**PCN: V19-007-476103-OA**

## **Product Change Notice**

Elimination of rubber band that bind the shipping tubes inside the ESD bag

Binding tubes with rubber band

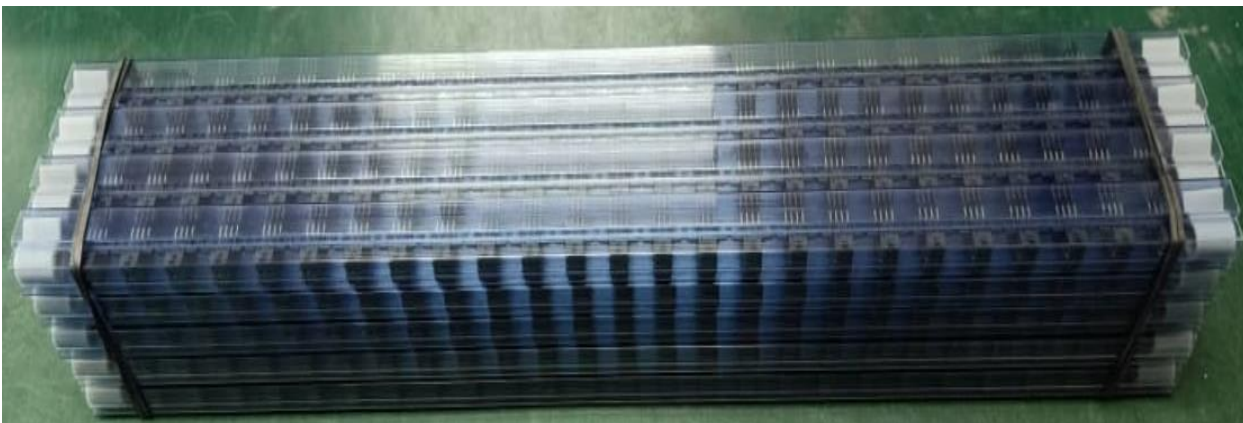
New packing method by eliminating rubber band to binding the shipping tubes

Before Change - Binding shipping tubes with rubber band

After Change – Packing the shipping tubes inside the ESD bag without rubber band.

Elimination of rubber band will avoid potential tube deforms at the customer side

Packing tubes inside ESD bag without  
rubber band
